Reference: NHTSA Identification Number 07V-092

# **Safety Recall G07**

## **Test and Reprogram Instrument Cluster**

*The reprogramming section of the service procedure has been enhanced with additional graphics to clarify the flash process.*

**Figure 8 – StarSCAN Sample Shown Before Flash**

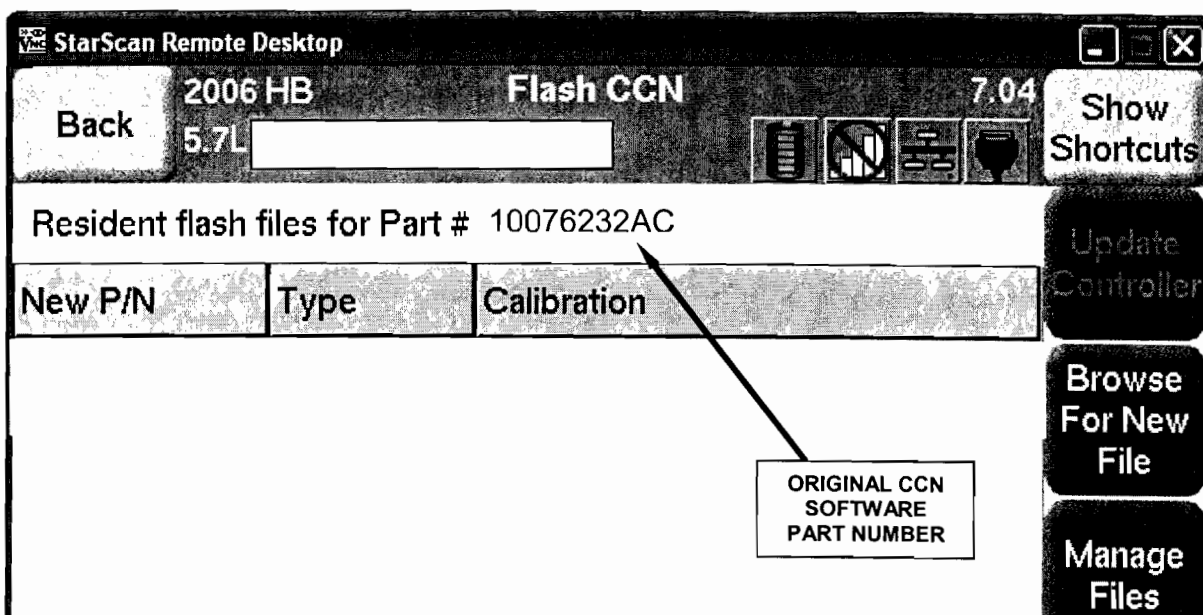
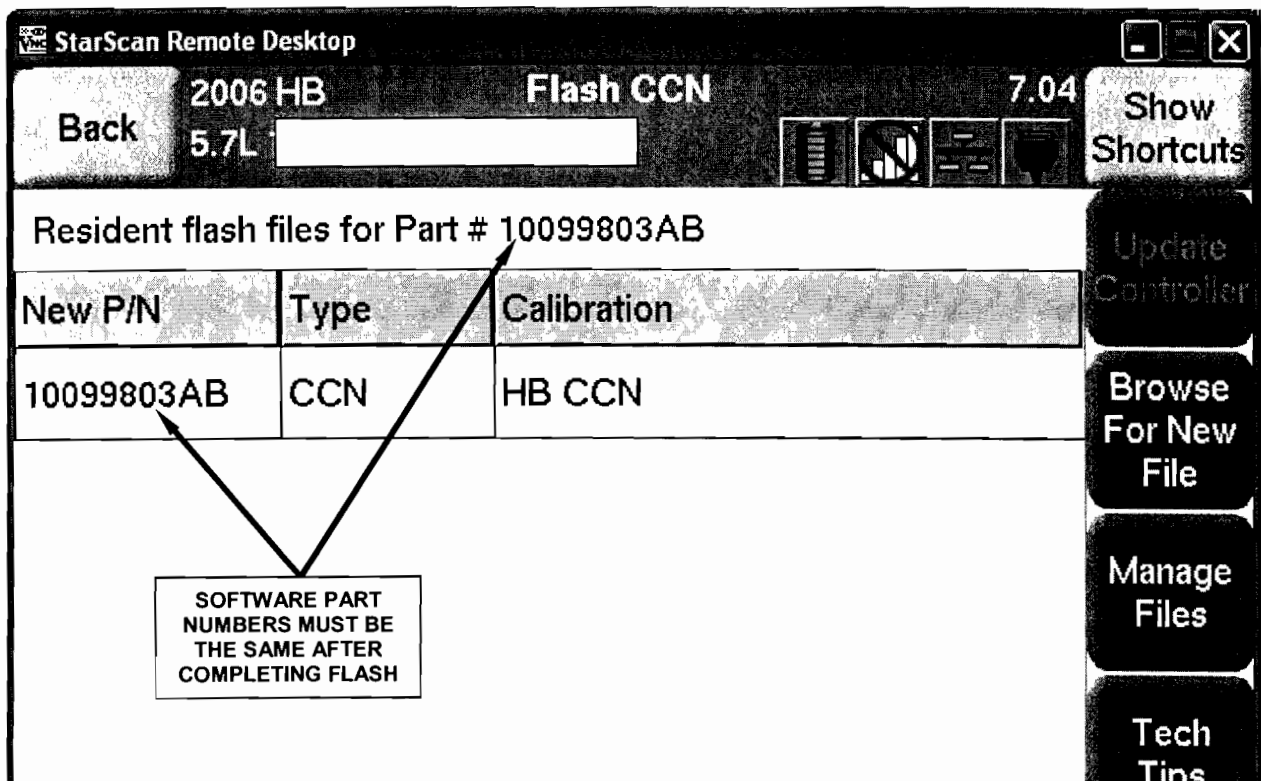
Enclosed are updated copies of the dealer communications which adds additional graphics to the reprogramming section of the service procedure to clarify the flash process.

3. Connect the CH9410 StarSCAN ethernet cable to the StarSCAN and the dealer’s network drop.
4. Select “**Browse for New File**” and follow the on screen instructions.
5. Highlight the calibration and then select “**Download to Scantool**”.
6. Select “**Close**” after the download is complete, then select “**Back**”.
7. Highlight the listed calibration.
8. Select “**Update Controller**” and follow the screen instructions.
9. When the CCN update is complete a pop-up box will appear that says “Flash Update Successful!” Select “**OK**”.
10. Verify the part number (resident flash file) at the top of the screen has updated to the new part number (Figure 9).
